ADDENDUM # 1

RFQ 7575502

**TITLE: Interior Renovations RIAG Building 150 South Main Street,
Providence**

This Addendum forms a part of the Contract Documents and modifies the Drawings and Project Manual as hereinafter indicated.

Issued On NOVEMBER 22, 2017

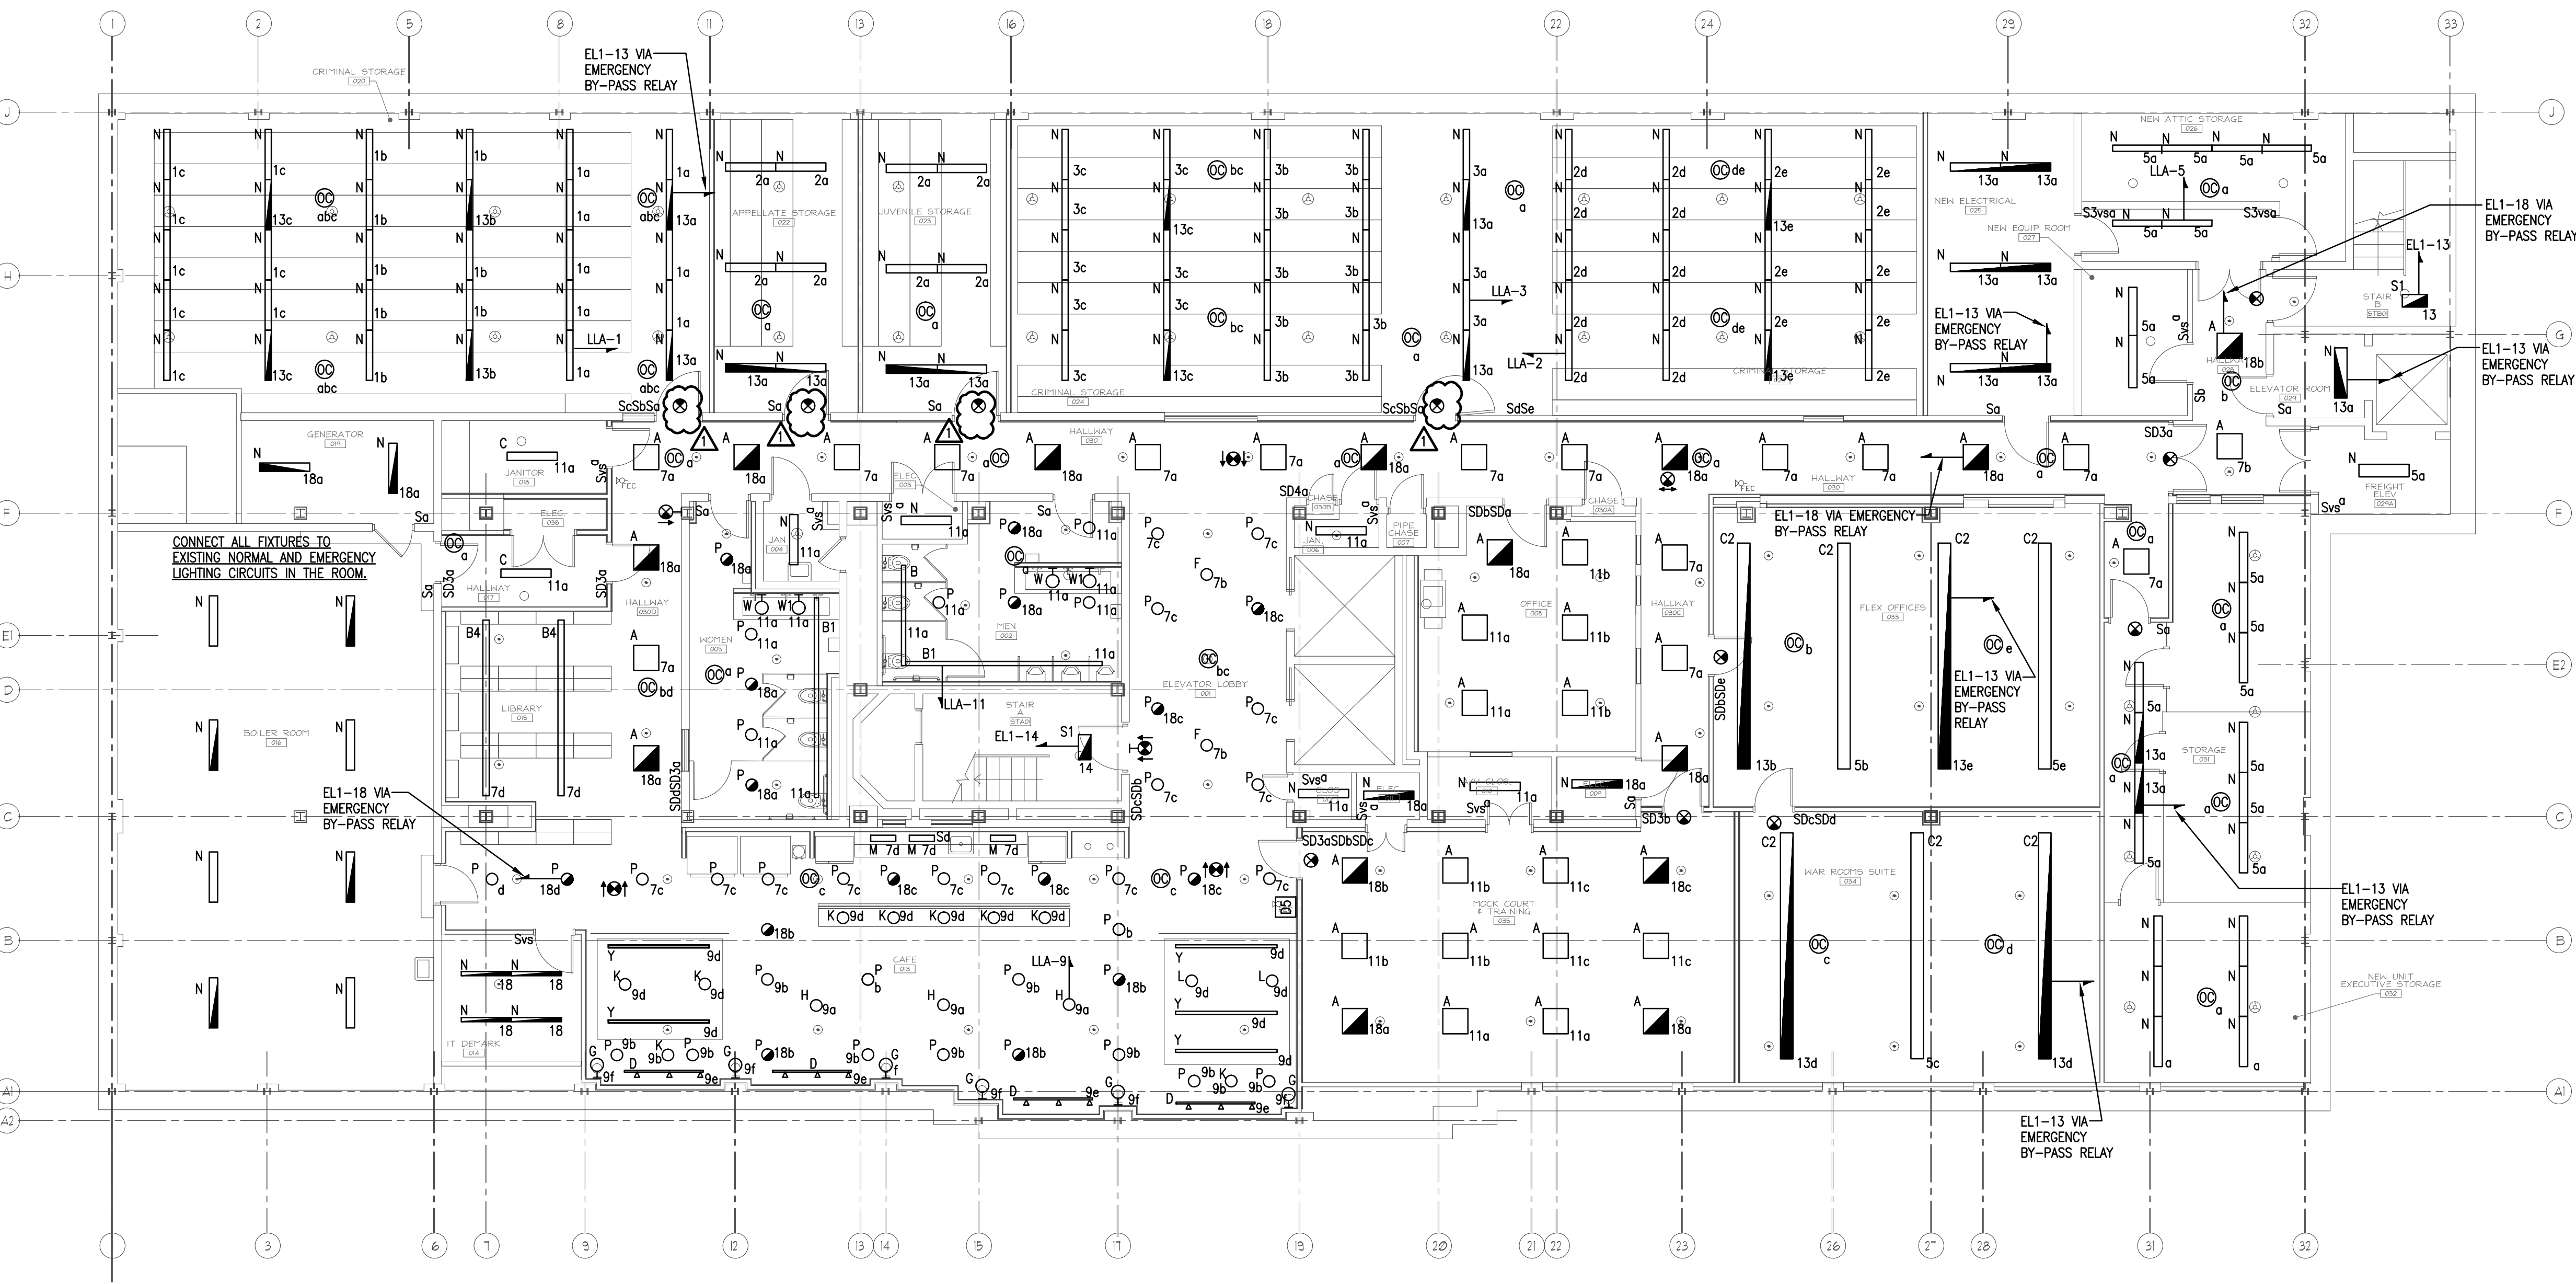
4. Drawing #ED101:
 - A. Keynote clarification.
 - B. Indicate existing feeder to existing elevators to be replaced with new feeders.
5. Drawing #E100:
 - A. Clarify disconnect switch rating at FPT-10.

Project Number: 9999
Drawing No. **E100**
Sheet of

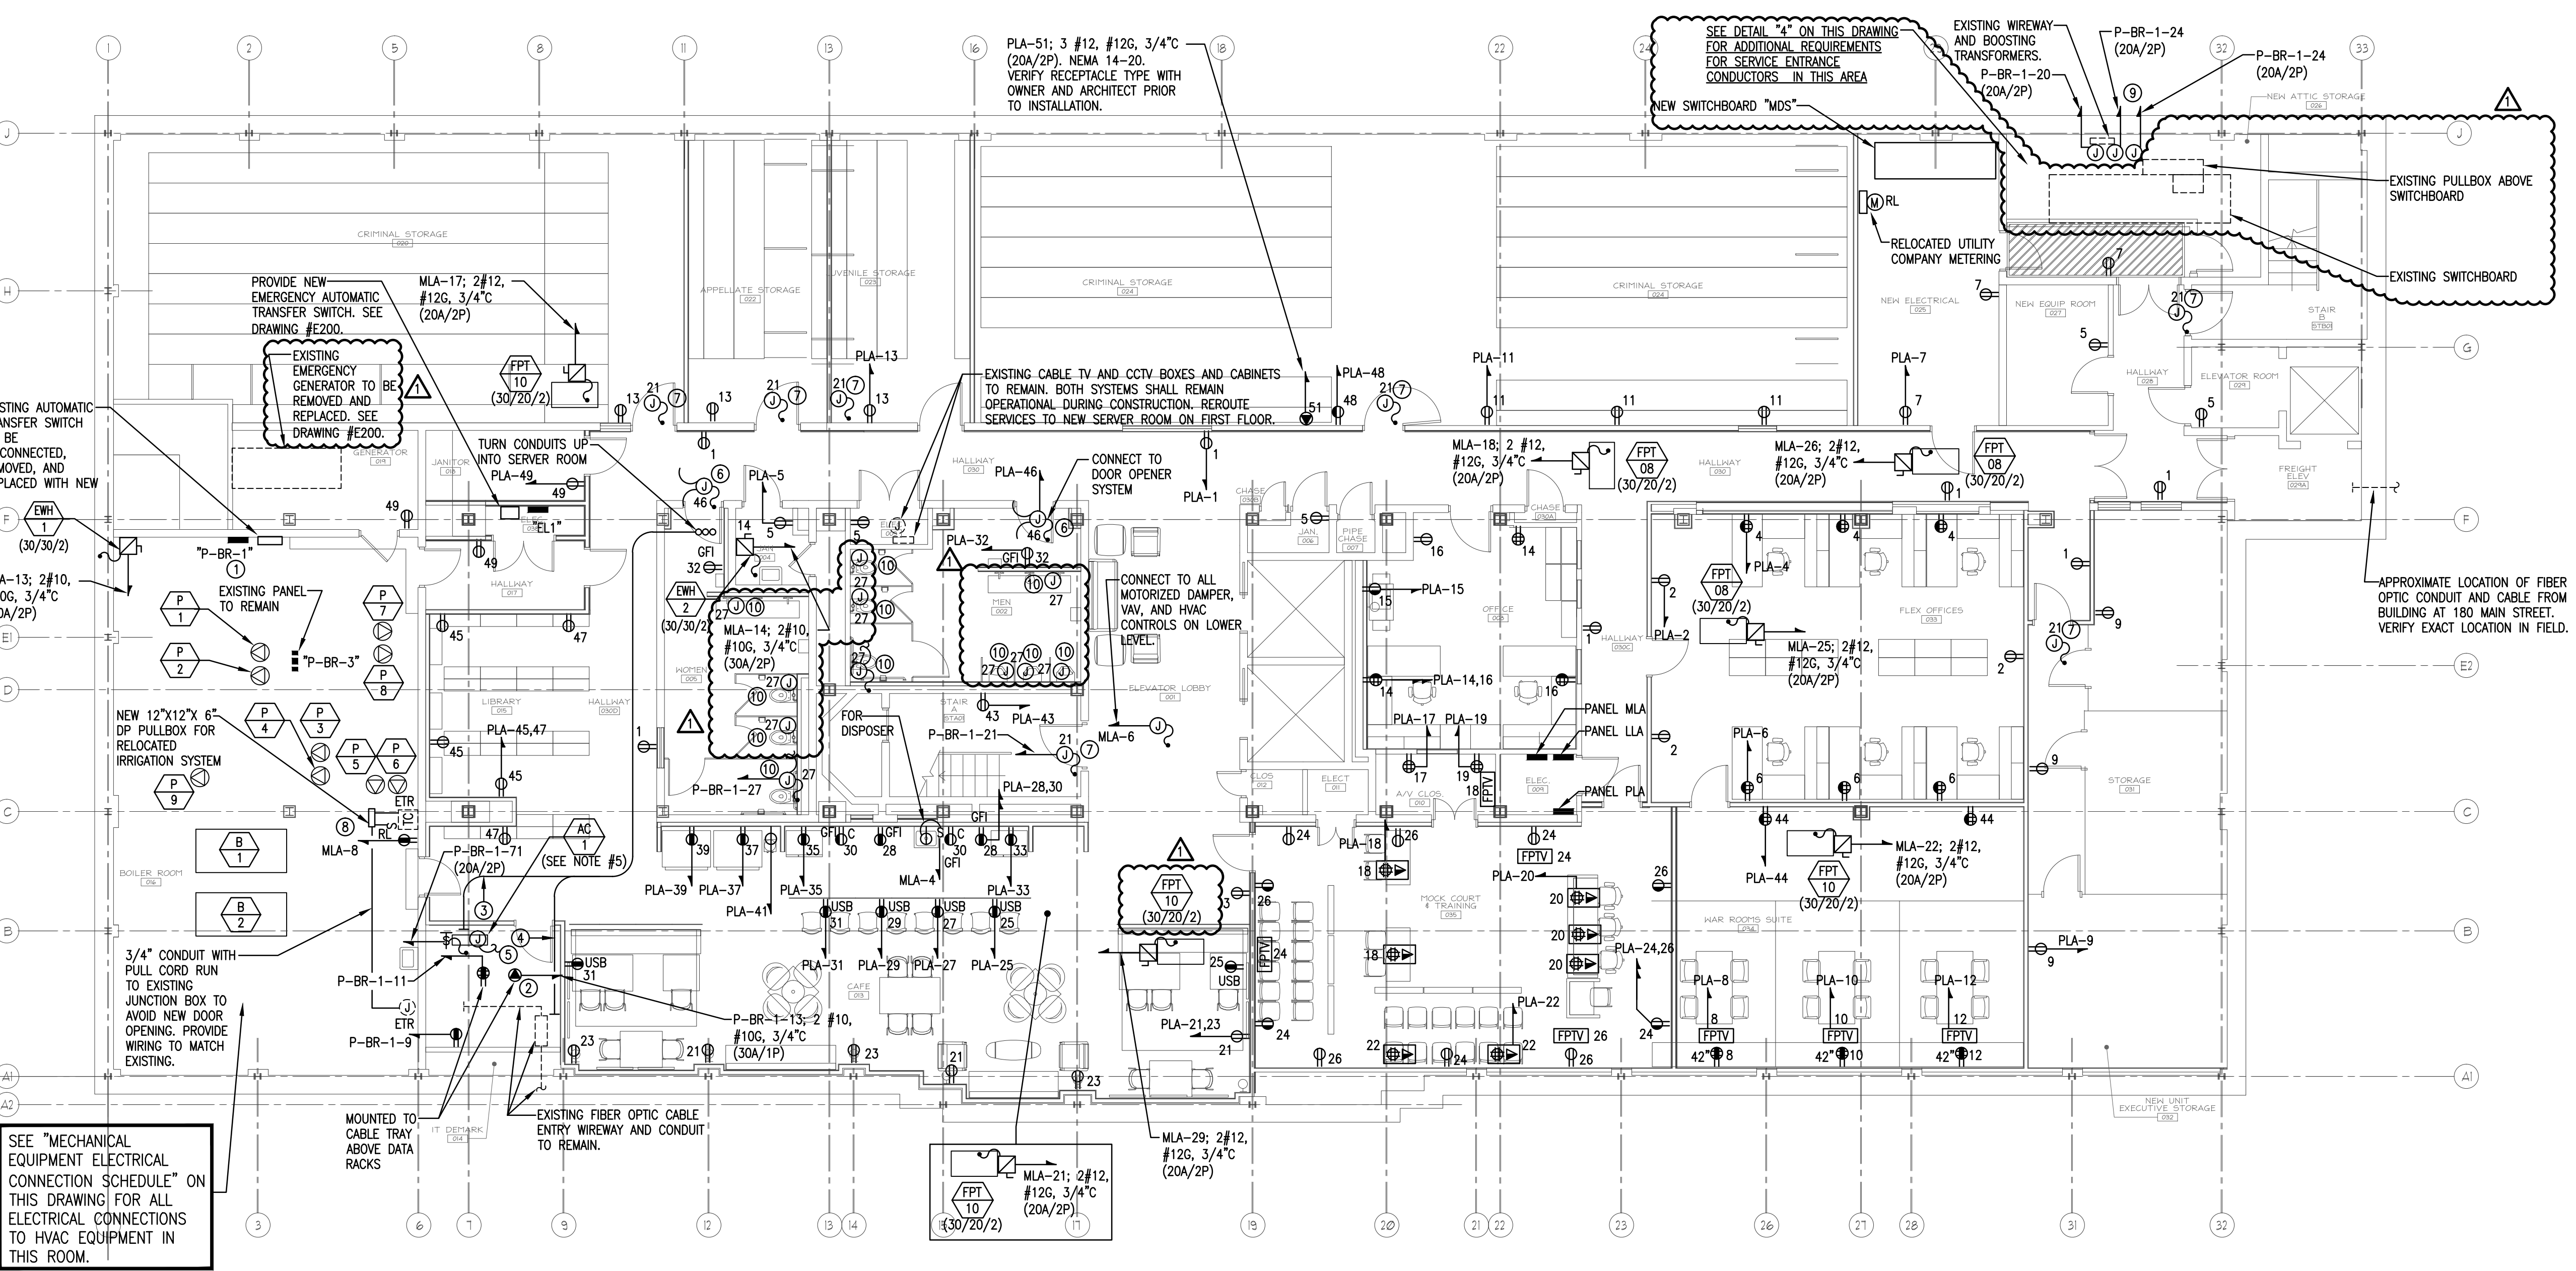
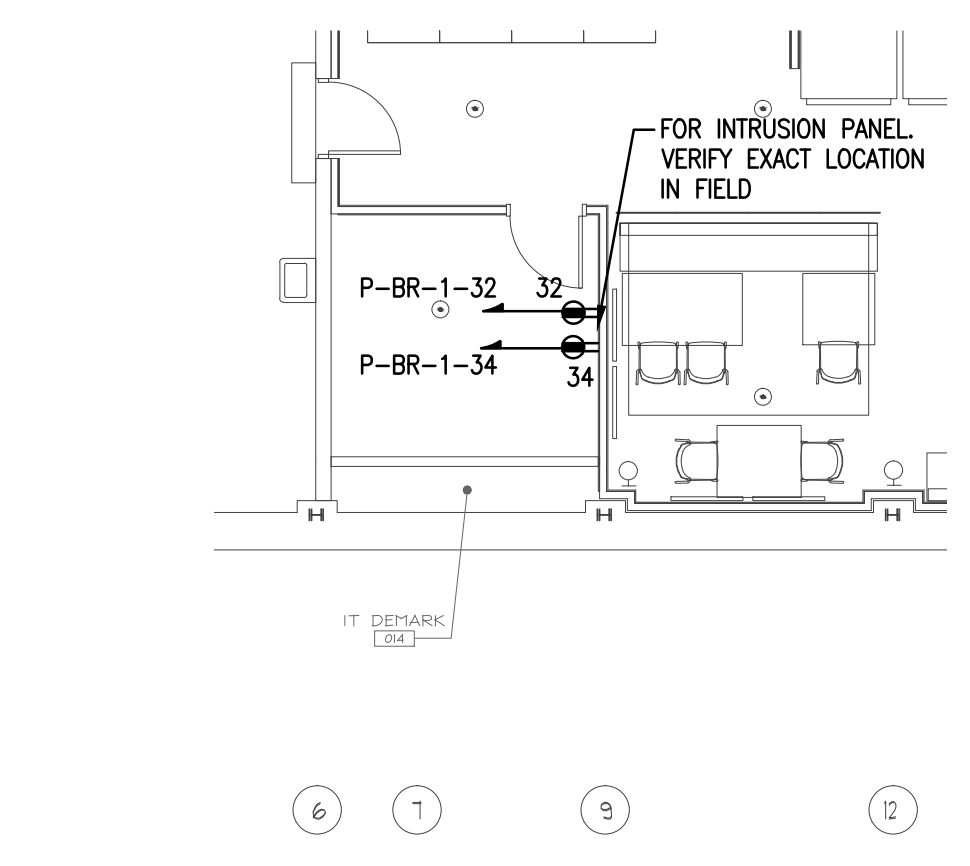
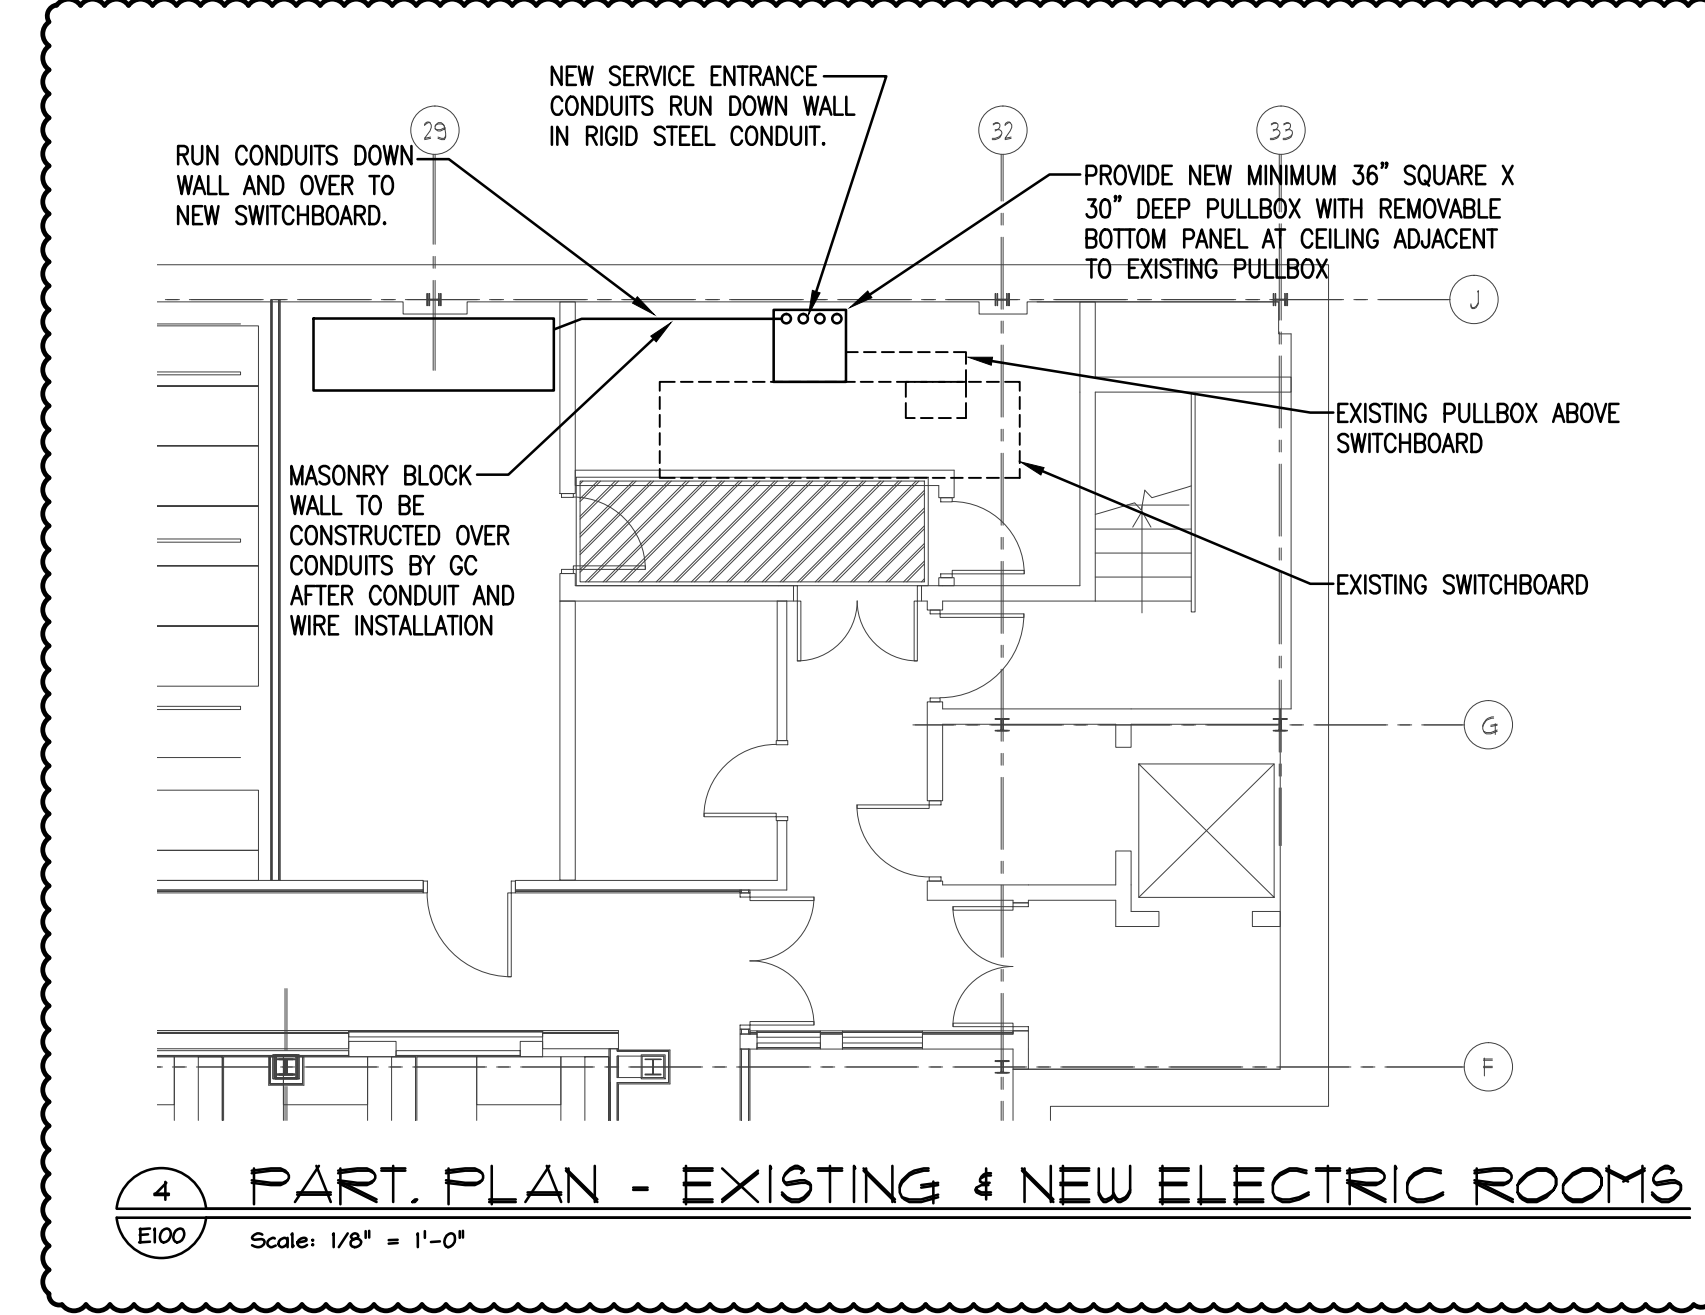
- B. Electric service entrance revision.
 - C. Add exit lighting.
 - D. Clarify toilet room flush valve power.
6. Drawing #E101:
 - A. Add exit lighting.
 - B. Clarify toilet room flush valve power.
